Development Review Committee Staff Report

Case No:	16DEVPLAN1184
Request:	Waiver from LDC section 10.2.4.B and 5.9.2.A.1.b.i and approval of the RDDP.
Project Name:	11911 Carrier Court
Location:	11911 Carrier Court
Acreage:	1.49 Acres
Owner:	Matthew Miller
Applicant:	Alex Rosenberg - AL Engineering Inc.
Representative:	Alex Rosenberg - AL Engineering Inc.
Jurisdiction:	Jeffersontown
Council District:	11 – Kevin Kramer
Case Manager:	Ross Allen – Planner I

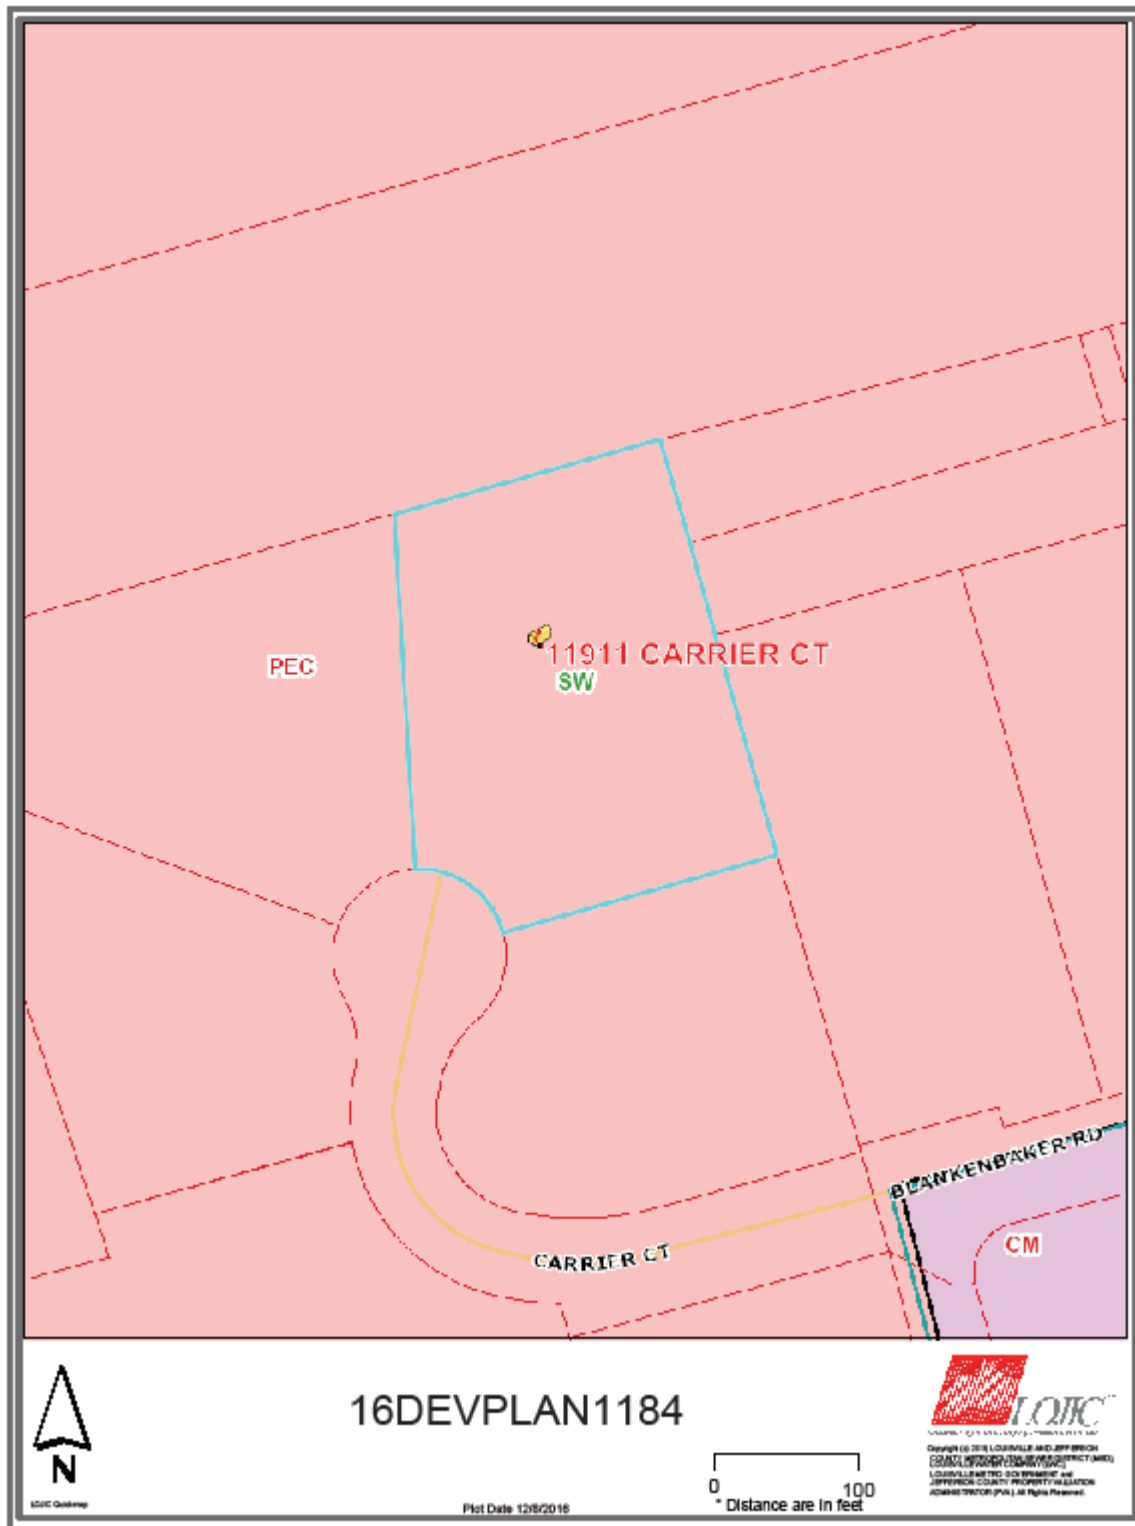
STAFF: The development plan conforms to requirements of the Comprehensive Plan and Land Development Code with the exception of the requested land development code waiver to allow a utility easement to overlap a Landscape Buffer Area by more than 50% and the waiver to not provide a pedestrian access from the public right of way to the proposed office/warehouse.

Based upon the information in the staff report, the testimony and evidence provided at the public hearing, the **Development Review Committee** must determine if the proposal meets the standards for granting the LDC Landscape Waiver from section 10.2.12.B, a General Waiver from section 5.9.2.A.1.b.i to not provide the pedestrian connection (sidewalk) from the public right of way, and the approval of the Revised District Development Plan for the proposed office/warehouse.
